**PUBLIC COMMENTS REPORT
ON
ICC A117.1 STANDARD
SECOND PUBLIC REVIEW DRAFT**

JANUARY 2, 2015

**ICC/ANSI A117.1 STANDARD
DEVELOPMENT - 2015 EDITION**

ICC A117.1 Standard – Accessible and Usable Buildings and Facilities Second Public Review Draft Public Comment Report – January 2, 2015

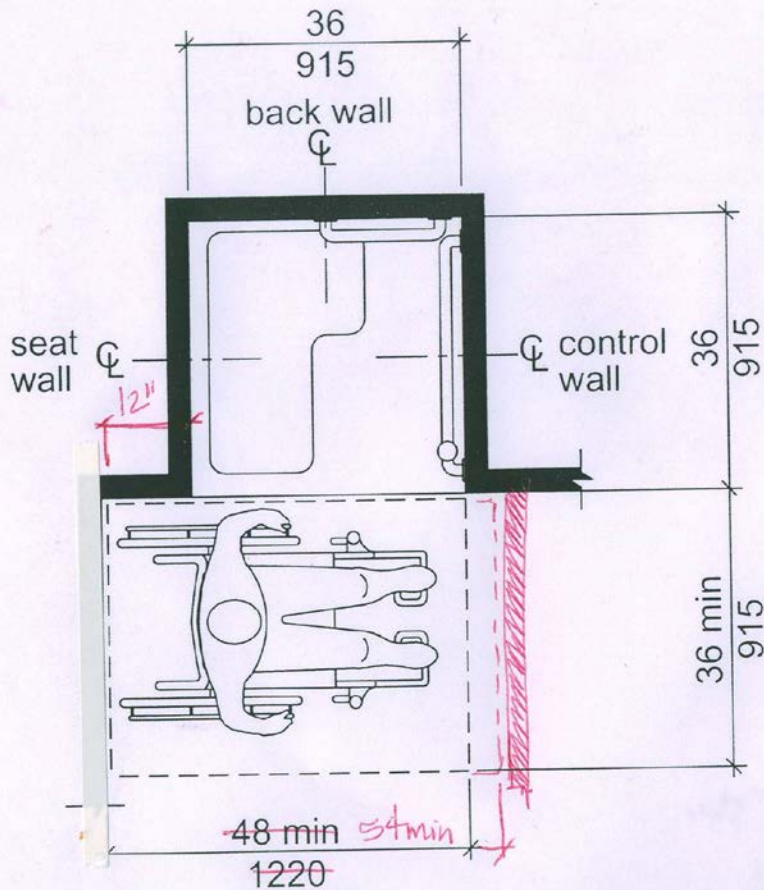
6-37-12 PC1	
Agenda Item #24	
Comment No: 6-37-12 PC1.1	Submitted by: Matt Sigler - PMI
	<p>Further revise as follows:</p> <p>606.5 Basin Location. The interior edge of the rim of the lavatory basin shall be located $3\frac{1}{2}$ inches (90 <u>150</u> mm) maximum from the front edge of the fixture or countertop.</p>
<p>Reason: PMI is very much against the original proposal of 3 inches, and this public comment that revises the dimension to 3-1/2 inches for the following reasons:</p> <ol style="list-style-type: none"> 1. There are many lavatories in the market that have been acceptable for years with setbacks of up to 5 or more inches to gain the required knee clearance as stated in Section 306.3. 2. According to studies conducted by Kohler, lavatories can be very uncomfortable even painful to use when the rims are moved so far forward on the counter as would be the case with the proposed language. People would be resting their forearms or wrists on the rims of the lavatories that can cause a pinching sensation of the wrists and soreness of the underside of the forearms. 3. The further forward a lavatory is set there is greater propensity for splashing because of the angle of discharge from the faucet. 4. There is no known study that supports the proposed setbacks. Therefore, a task group should be formed to review this proposal before being considered by the committee for inclusion into the standard. <p>As it is too late in the process to eliminate this new requirement, we are offering a dimension that should be appropriate for the fixtures that are available on the market and provides that the original issue is still addressed. We are still researching with our member manufacturers as to what would be the best distance. We will bring out findings to the February 2015 meeting and may suggest a distance different than 6 inches.</p>

6-37-12 PC1 - AS PUBLISHED 2ND PUBLIC REVIEW DRAFT	
<p>Revise as follows:</p> <p>606.5 Basin Location. The interior edge of the rim of the lavatory basin shall be located $3\frac{1}{2}$ inches (75 <u>90</u> mm) maximum from the front edge of the fixture or countertop.</p>

Typeface: Helvetica Neue 25 Ultra Light

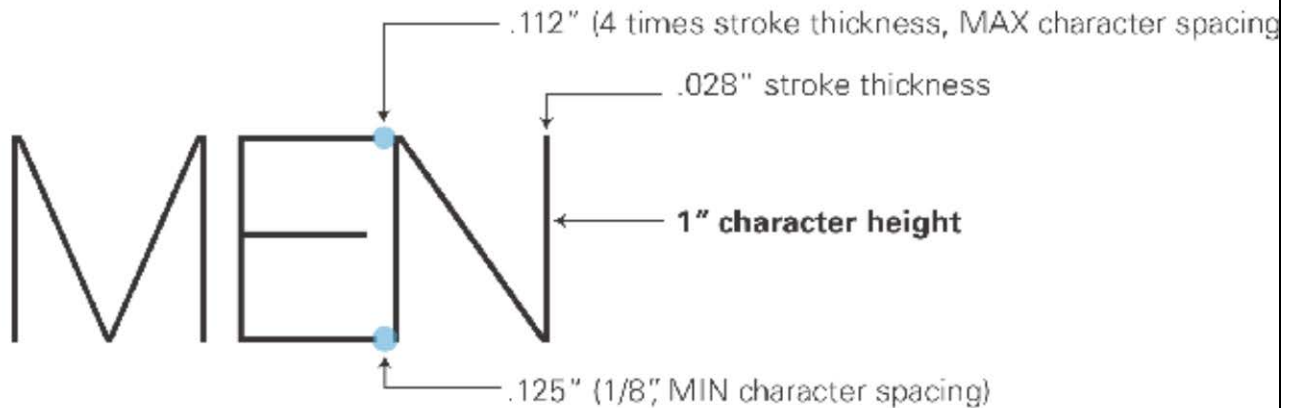
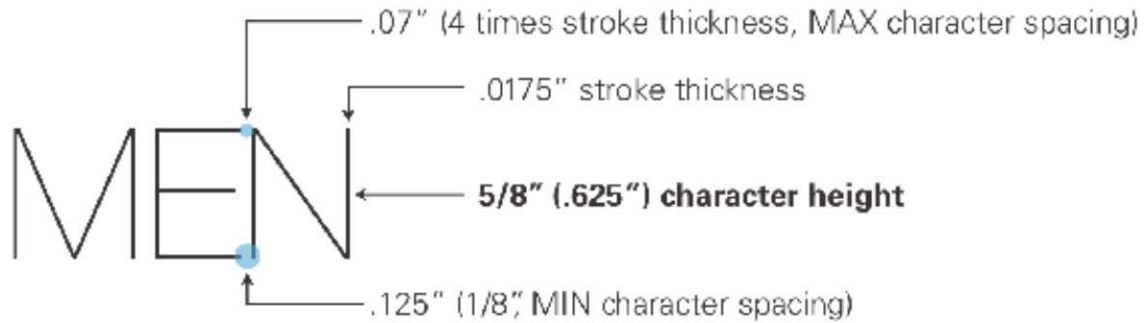
7-23-12 PC1	
Agenda Item #36	
Comment No: 7-23-12 PC1.1	Submitted by: Teresa Cox – APCO Sign Systems, Inc., on behalf of ISA
	<p>Further revise as follows:</p> <p>703.3.8 Character Spacing. Character spacing shall be measured between the two closest points of adjacent raised characters within a message, excluding word spaces. Spacing between individual raised characters shall be <u>15% or 1/8 inch (3.2 mm) minimum, whichever is greater, and 35% maximum of the character height</u> measured at the top of the surface of the characters, 1/16 inch (1.6 mm) minimum measured at the base of the characters, and four times the raised character stroke width maximum. Characters shall be separated from raised borders and decorative elements 3/8 inch (9.5 mm) minimum.</p>
<p>Reason:</p> <p>During our meeting in January 2014, the question was called on 7-23-12 before ISA was able to give a full explanation of the sign industry's concern. The Committee voted to reverse the action taken the previous July to address a problem with language defining maximum spacing between raised characters.</p> <p>The current standard reads: "Spacing between individual raised characters shall be 1/8 inch (3.2 mm) minimum ... and four times the raised character stroke width maximum."</p> <p>As there is no minimum stroke width for raised characters, there are instances where the 1/8 inch minimum exceeds the maximum. A PDF is attached illustrating the problem.</p> <p>Good design practice in signage maintains proportional spacing between characters. Spacing between characters should increase with character height. Proportional spacing enhances legibility and accessibility. Using a percentage of the character height is a logical way to define spacing between characters.</p> <p>The ISA did not propose to change the minimum spacing, but to allow for wider spacing than four times the stroke width.</p>

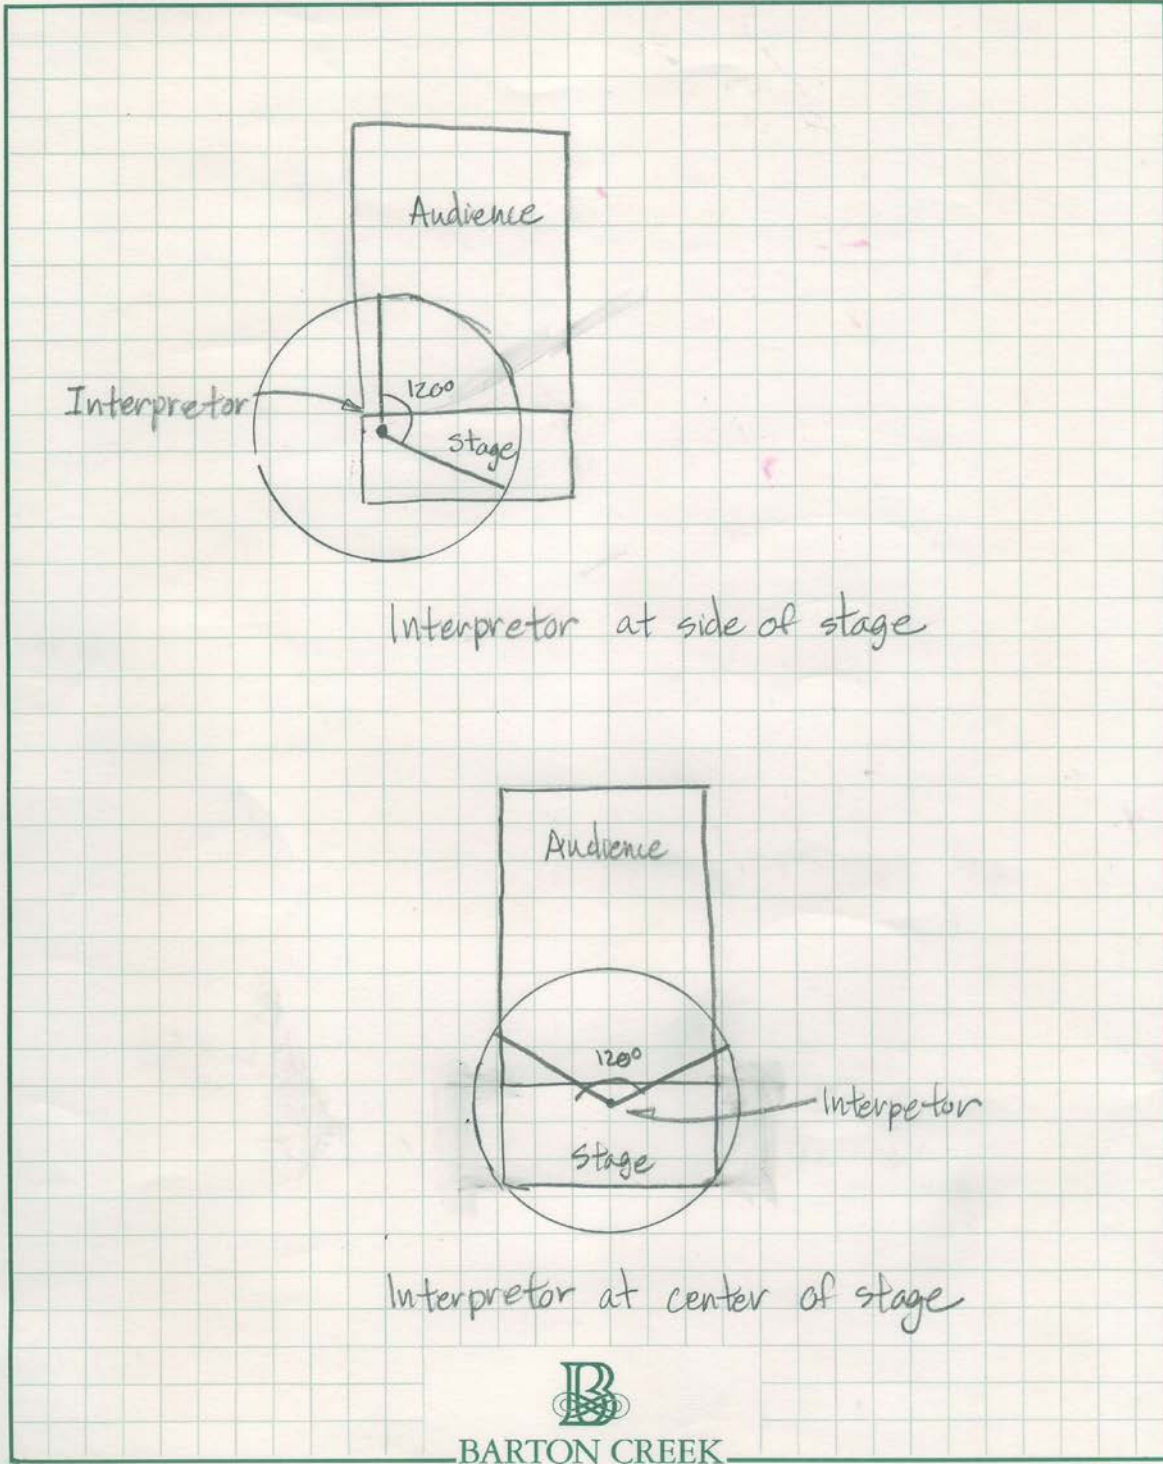
802.11.2 - The word subtend is defined in the dictionary as follows:

In geometry, an angle subtended by an arc, line, or other curve is one whose two rays pass through the endpoints of the arc. The precise meaning varies with the context. For example, one may speak of the angle subtended by an arc of a circumference when the angle's vertex is a point on the circumference. A simple theorem of plane geometry states that arcs of equal lengths subtend equal angles in such a situation.

Assuming this is the range for where the seats that have a good view of the interpreter are required, if an interpreter was standing in the middle of the stage, this might be doable. However, the most common place for an interpreter is at the side of the stage. This literally would require the viewing area to be behind them. See Figures. The maximum” could be read to indicate that the angle could be anything up to that range in width – including 0 degrees – which I don't think was the intent. ‘Unobstructed’ to 65 feet could be interpreted to not allow any columns in the room in that area. Thus the room we have our A117.1 meetings in would be in violation. Since an interpreter could be of any height, using the size of the interpreter for the viewing range is not consistent.

The intent of the revisions to the last sentence is intended to provide more precise information of measurement. However, this requirement should probably be deleted because it could prohibit seating immediately in front of the interpreter when the interpreter is on any type of raised platform or stage.
